ASSESSMENT REPORT

Awaba Waste Management Facility Expansion Project Modified Staging, Stormwater and Leachate Management Section 75W Modification - MP 10_0139 MOD 1

Figure 3 – Modified Landfill Layout (correction to plan only)

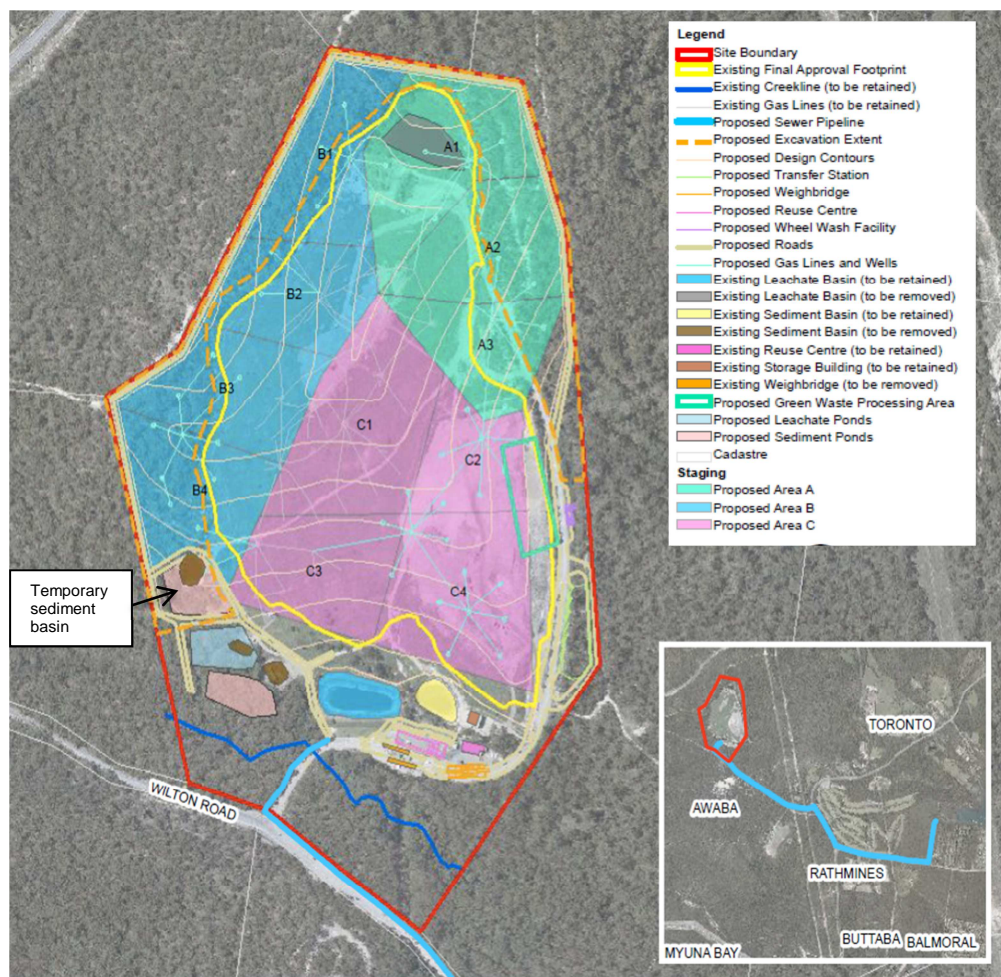
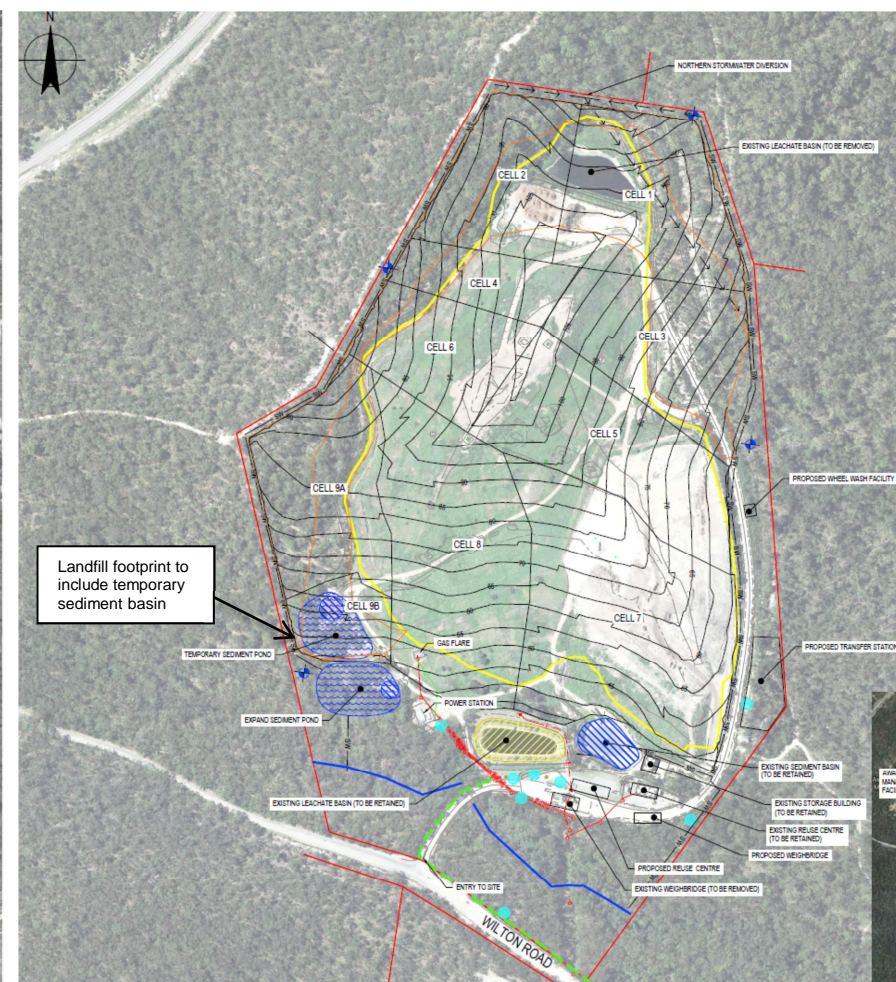
- a correction to the approved landfill layout plan to show the temporary south-west sediment basin within the landfill footprint (as assessed in the original Environmental Assessment for the project application), see Figures 2 and 3;
- a change to nine landfill cells constructed in five stages, compared with the approved eleven landfill cells constructed in three stages, see Figures 4 and 5; and
- modifications to the stormwater and leachate management system (see Figures 6 and 7), including:
 - removal of a 6-8 megalitre (ML) leachate basin in the south-western part of the landfill; and
 - construction of a concrete containment and diversion structure at the northern site boundary to divert clean stormwater away from the landfill.

Figure 5 – Modified Staging Plan

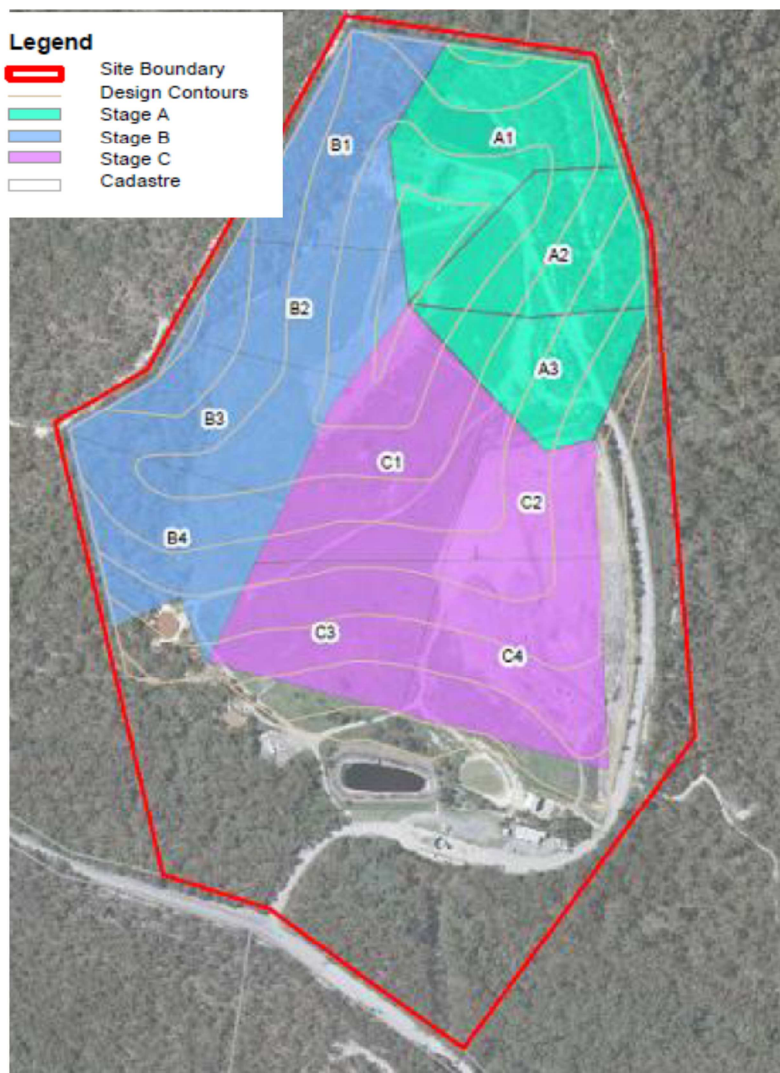
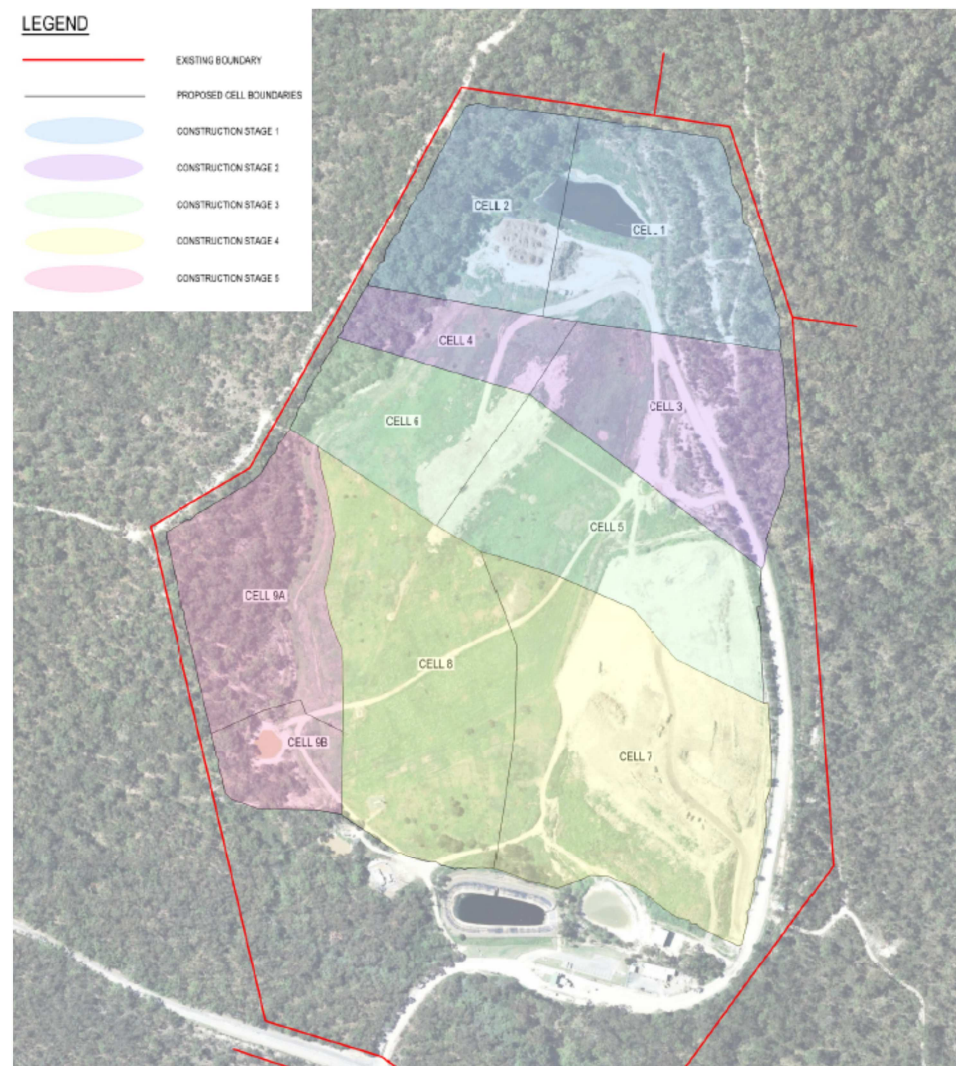
Issue	Assessment	Recommendation
Staging	<ul style="list-style-type: none"> • The change from three construction stages to five is proposed to optimise the landfill design and operating efficiency by: <ul style="list-style-type: none"> - preventing the construction of large lined areas ahead of landfilling which may be excessively exposed to ultraviolet radiation and weathering; - minimising stormwater capture and leachate generation through a smaller working cell area; - improved cell shape optimising control of the working tip face thereby minimising the quantity of exposed waste; and - better facilitate progressive capping and rehabilitation. • The Department has considered the proposed modification to staging and concludes that there would be a minimal change in impacts from the approved project. • As noted by LMCC, the reduction in cell size would assist in minimising odour and would reduce vermin attraction. The facilitation of progressive capping would also reduce leachate generation, improve surface water quality, and minimise odour. • The modified staging would not alter the approved contours or visual impacts of the final landform. • The EPA did not raise any concerns with the modified staging. • The Department concludes that the modified staging is likely to result in minor improvements to approved impacts. • The existing conditions require the cell design to be undertaken to the satisfaction of the EPA. • The Department considers that no further conditions are required. 	<p>Recommend administrative changes to the conditions, including:</p> <ul style="list-style-type: none"> • replacing the Staging Plan in Appendix 4 with a new staging plan; and • amending the Statement of Commitments in Appendix 1 to correct references to the number of stages.

Figure 7 – Modified Stormwater and Leachate Management Infrastructure

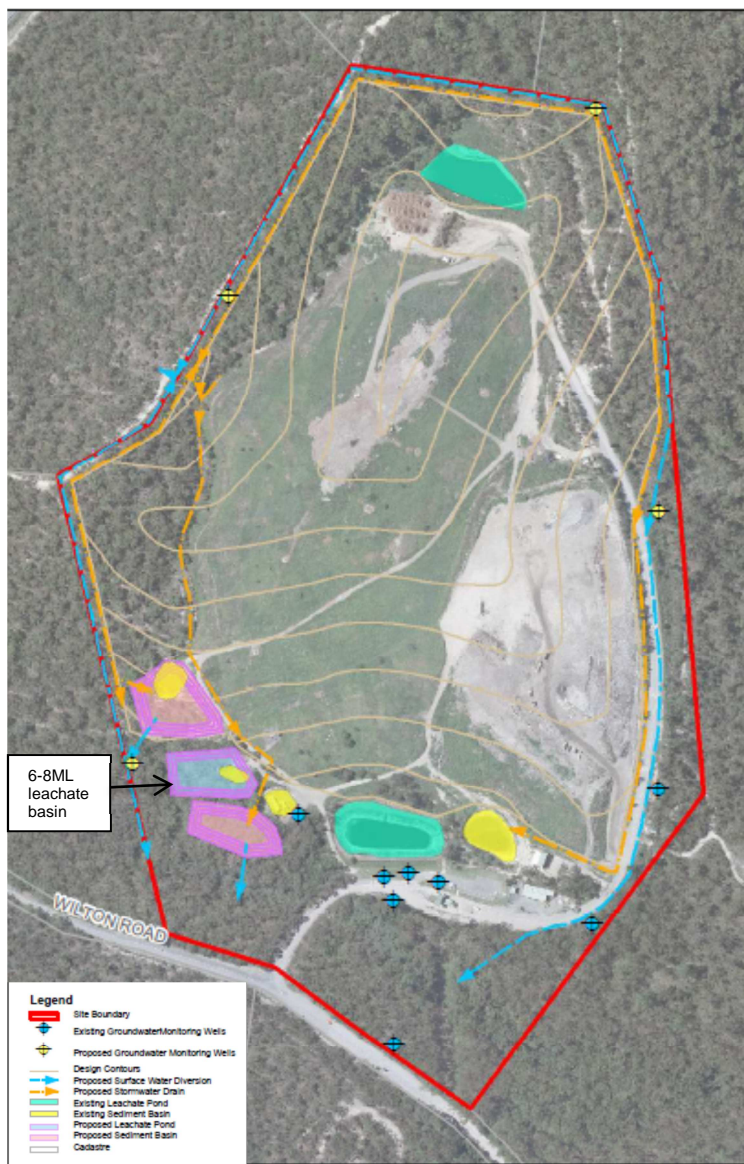
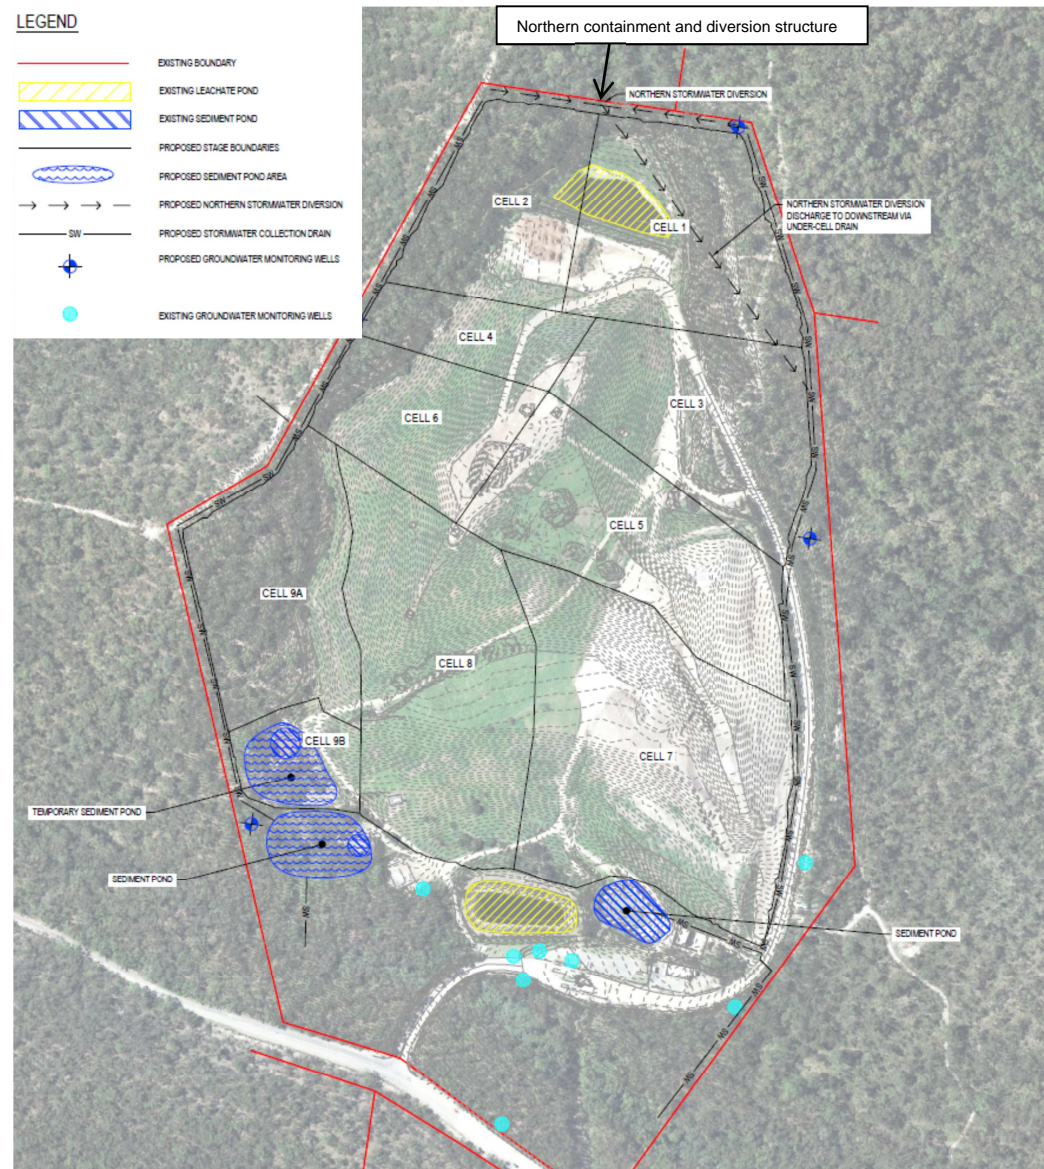
Stormwater Management	<p><u>Northern Containment and Diversion Structure</u></p> <ul style="list-style-type: none"> • The proposed concrete containment and diversion structure in the northern part of the site would divert clean stormwater away from the landfill, to prevent mixing with leachate. • The requirement for the structure was determined following detailed modeling of the final landform. • The structure would be less than 2 metres high and would include an under cell drain to divert clean stormwater to the eastern perimeter of the landfill for discharge, mimicking the existing surface flow pattern (see Figure 7). • The structure would be located in the 10 metre northern boundary setback, which was assessed as part of the original project and approved for clearing. • The Department is satisfied that construction of the containment and diversion structure would have minimal additional impacts and would improve the management of surface water. <p><u>South West Temporary Sediment Basin</u></p> <ul style="list-style-type: none"> • The proposed correction to the plans to show the temporary sediment basin incorporated into the final landfill footprint is an administrative change only. This aspect was assessment as part of the original project approval. • The conditions of approval require the stormwater management system to be designed and installed to the satisfaction of the Department; hence no further conditions are required. 	<p>Recommend administrative changes to the conditions, including:</p> <ul style="list-style-type: none"> • replacing the plan in Appendix 6 with a new plan of stormwater and groundwater management infrastructure; • replacing the plan in Appendix 3 with a corrected layout plan incorporating the sediment basin in the final landfill footprint; and • amending the Statement of Commitments in Appendix 1.

Leachate Management	<p><u>Removal of Leachate Basin</u></p> <ul style="list-style-type: none"> • Following detailed modeling, LMCC determined that the proposed 6-8 megalitre (ML) leachate pond in the south-western part of the landfill would not be required. • Modeling confirmed that the existing leachate pond and the pipeline to the Rathmines No. 6 waste water pumping station provides adequate storage and treatment capacity for the expanded landfill. • LMCC noted that there would be minimal change in impacts from 	<p>Recommend administrative changes to the conditions, including:</p> <ul style="list-style-type: none"> • replacing the plan in Appendix 6 with a new plan of stormwater and groundwater management infrastructure.

Issue	Assessment	Recommendation
	<p>removing the proposed leachate pond with a potential reduction in odour generation.</p> <ul style="list-style-type: none"> • The Department agrees that removal of the leachate pond would have minimal impacts. • The EPA requested confirmation that GHD (landfill design consultants) were satisfied that the leachate basin could be removed. GHD confirmed that they were satisfied. • The conditions of approval require design and installation of the leachate management system to the satisfaction of the EPA and the Department. No amendment or further conditions are required.
